Preferred Project Report

MP 10/0205

Kanangra Drive Gwandalan
Lot 3 DP 588206

Lakeside Living Pty Ltd

Updated subdivision plan

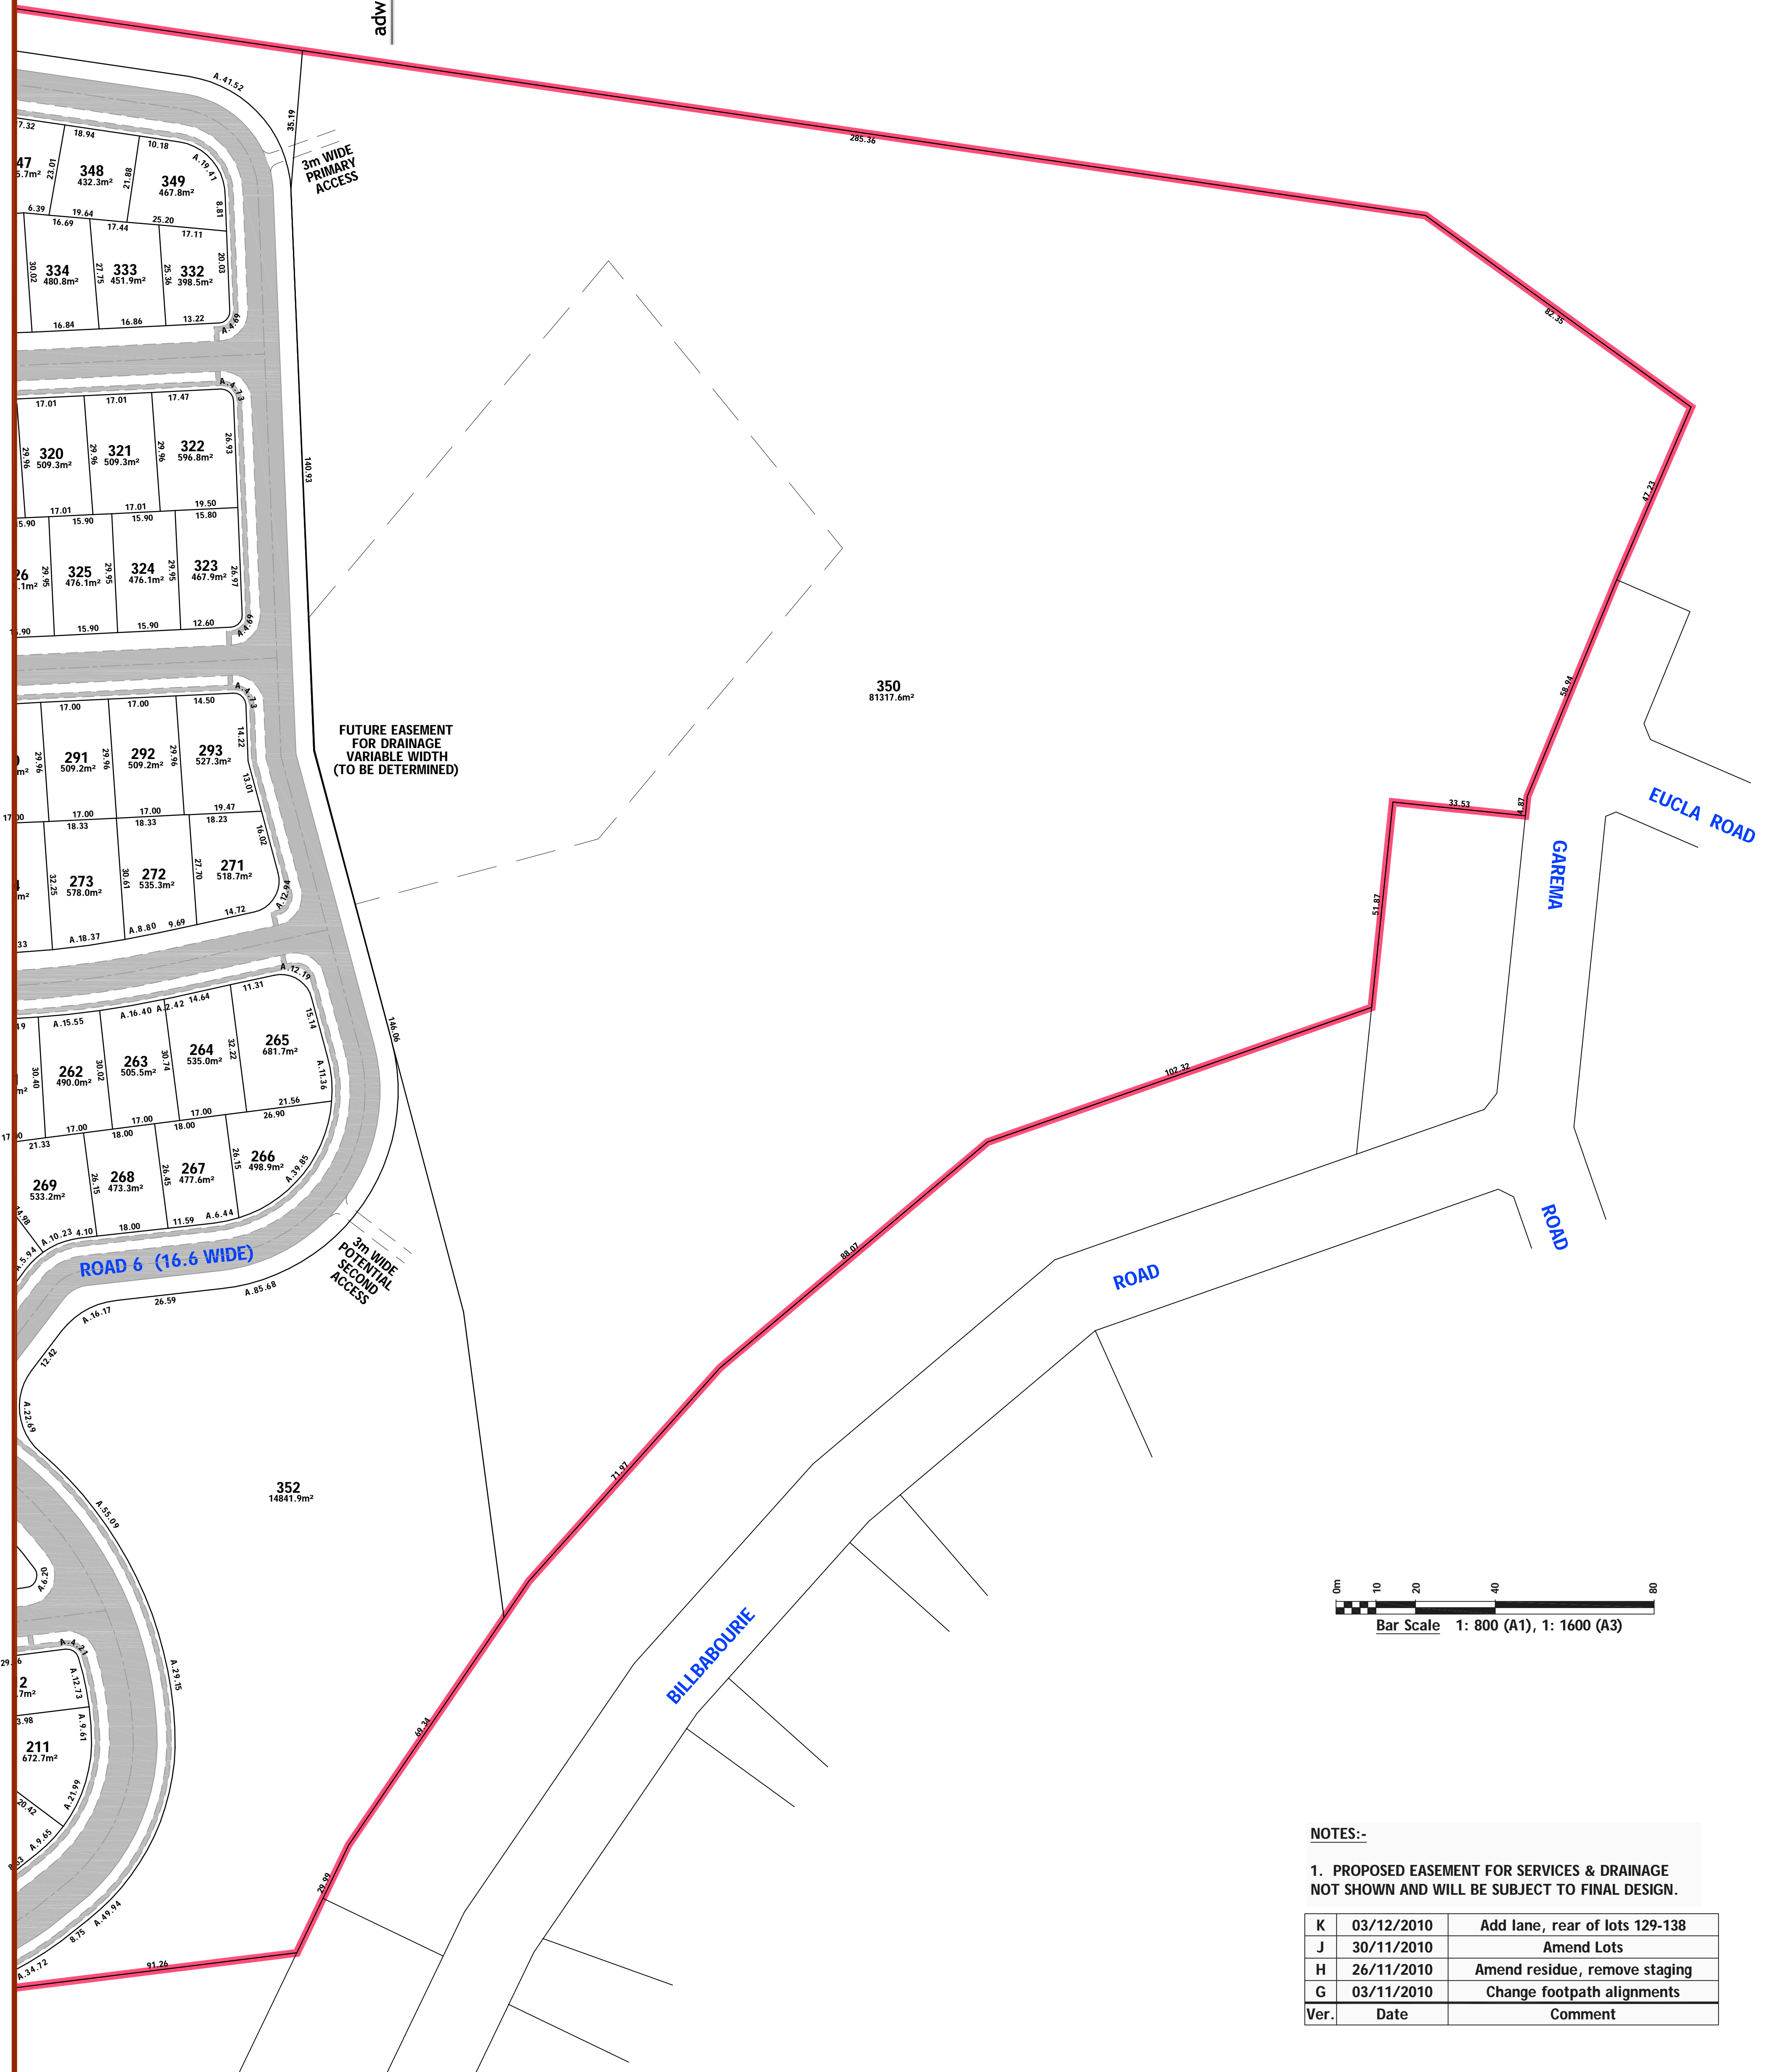
The subdivision plans, Appendix E, have been modified to show the location of two points of access to the dwelling off Road 6. The access is also shown on the landscape plans. The access points will be subject to final design and location on construction certificate plans.

Ver.	Date	Comment
K	03/12/2010	Add lane, rear of lots 129-138
J	30/11/2010	Amend Lots
H	26/11/2010	Amend residue, remove staging
G	03/11/2010	Change footpath alignments

Title **DETAIL PLAN - SOUTH EAST PARK**
 Date November 2010
 Dn/Ch JR/UB
 Dwg No 10630-L-302
 Issue A

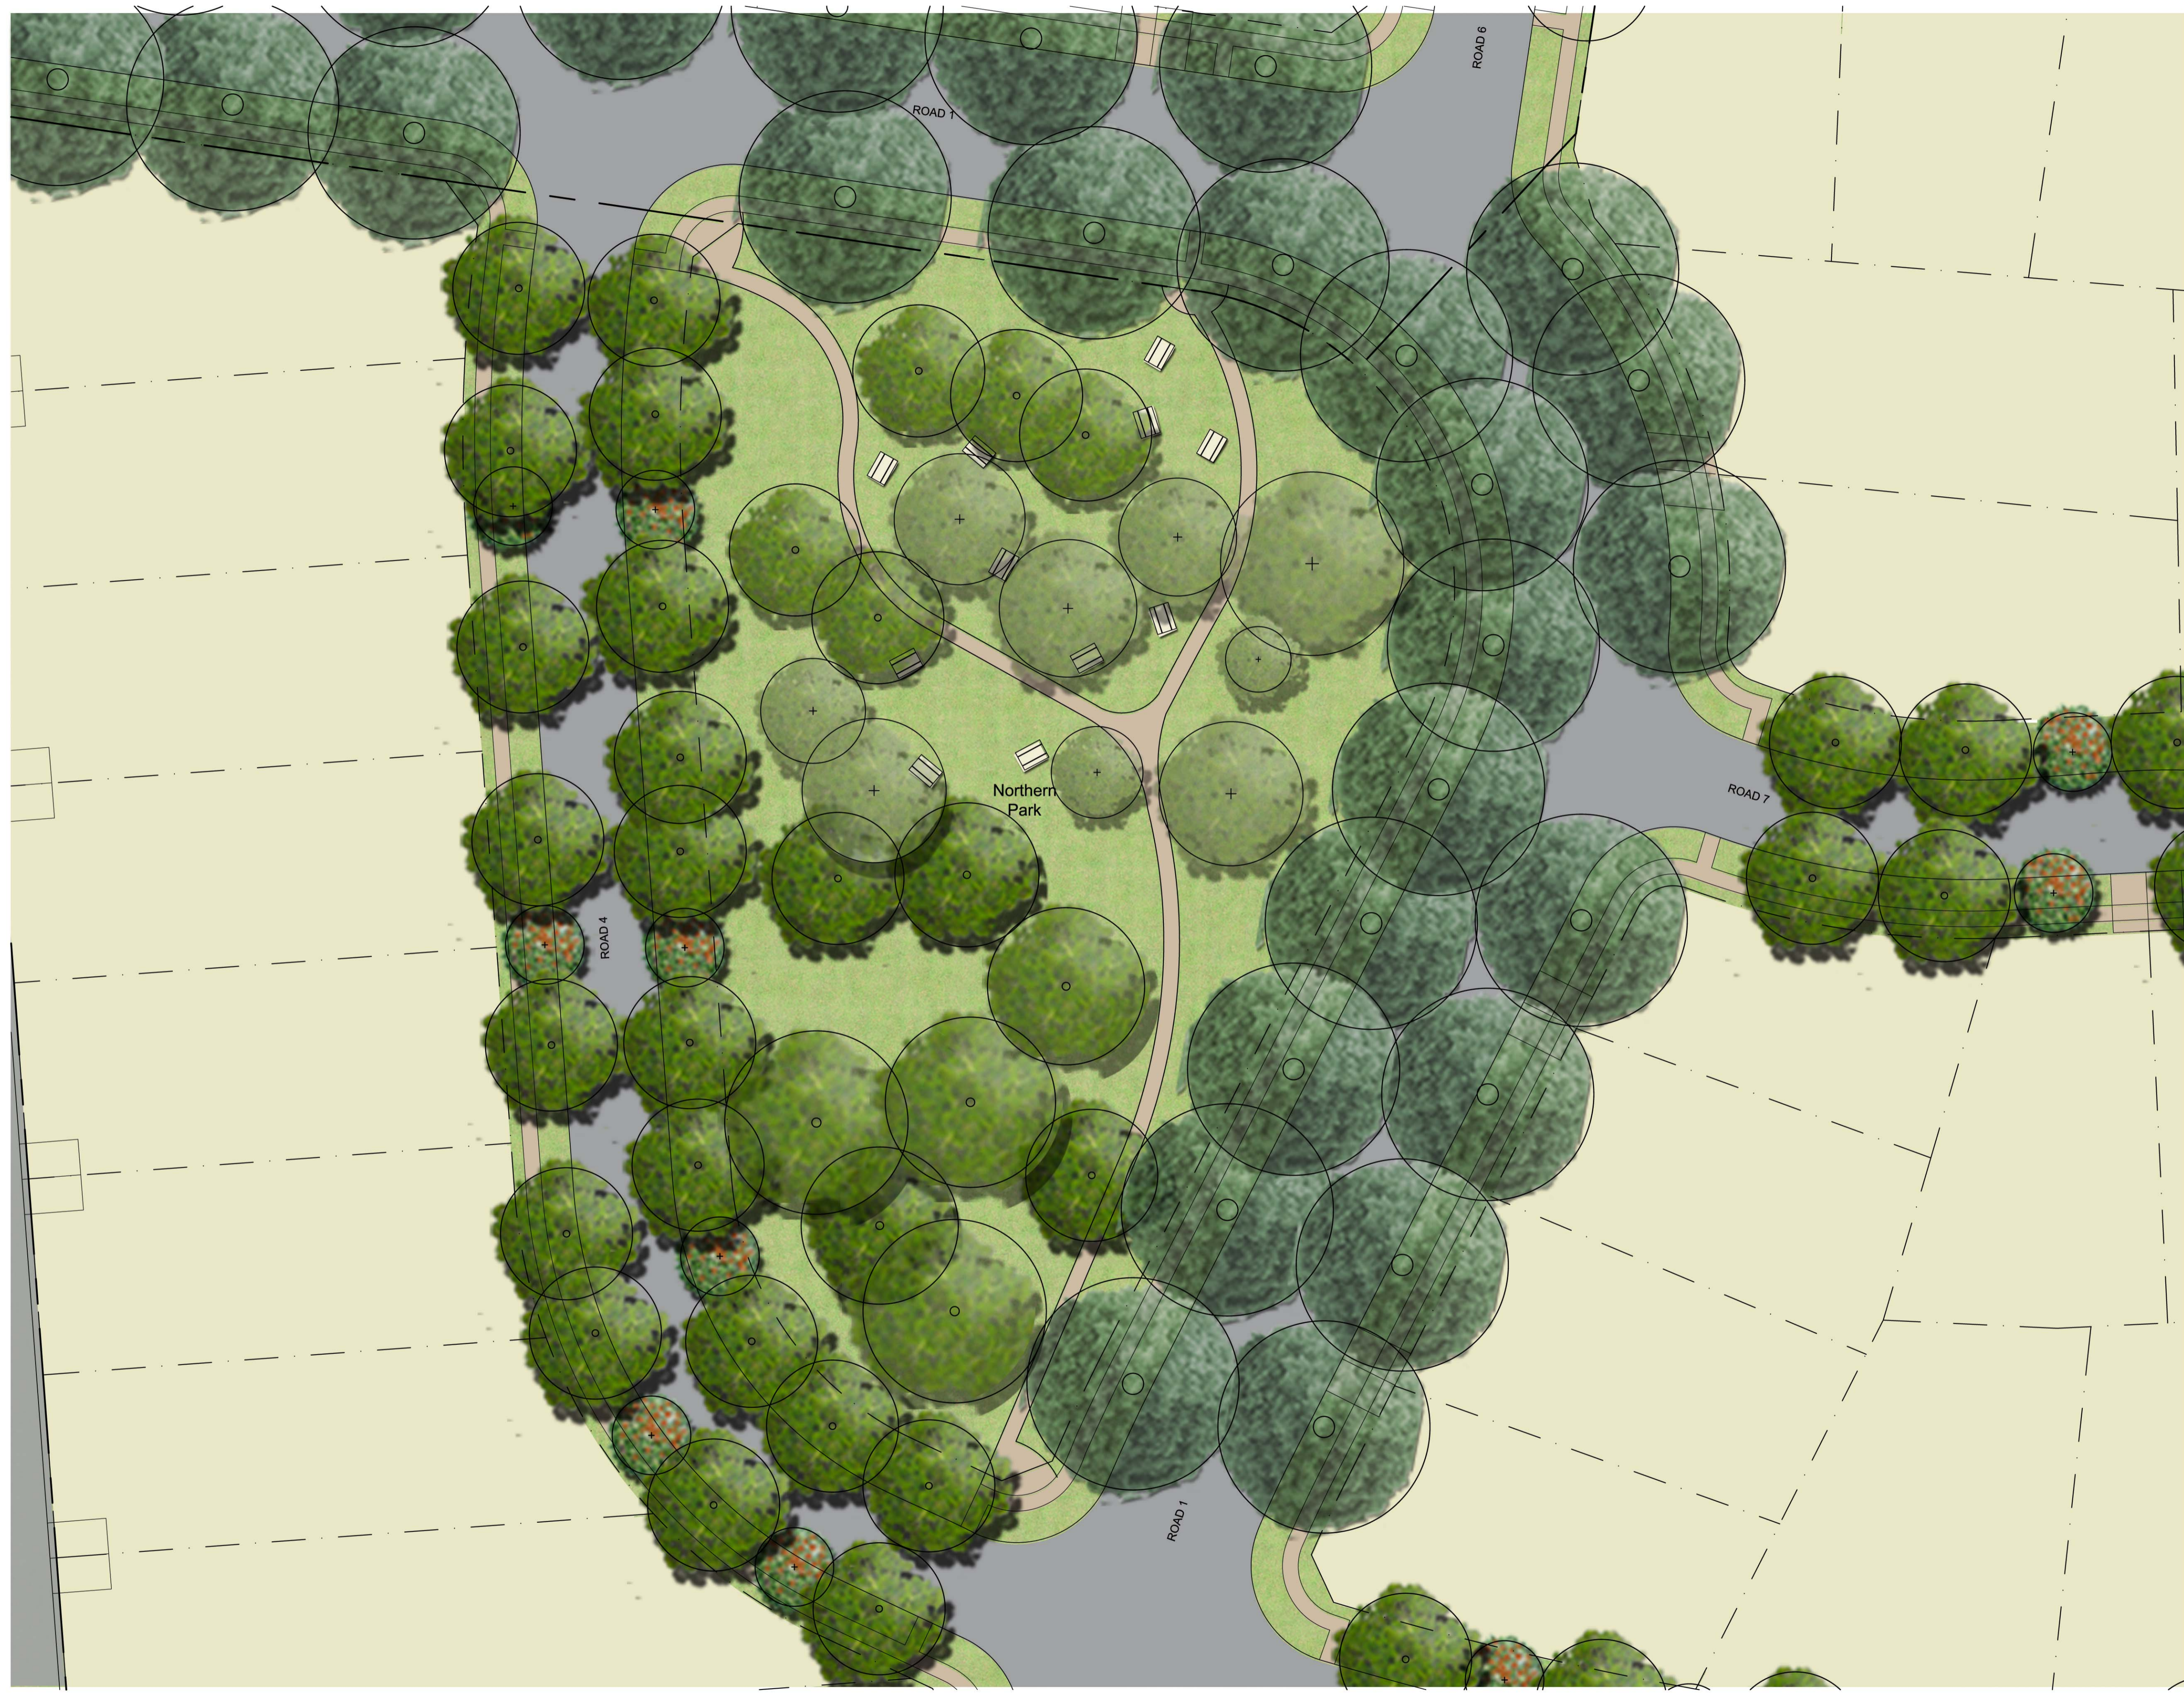
1.7	Play, exercise and social engagement opportunities should be provided in both parks.	Refer to landscape plans submitted with PPR.
1.8	Documents should show location of WSUD devices.	Swale and constructed wetland shown on engineering concept plans.
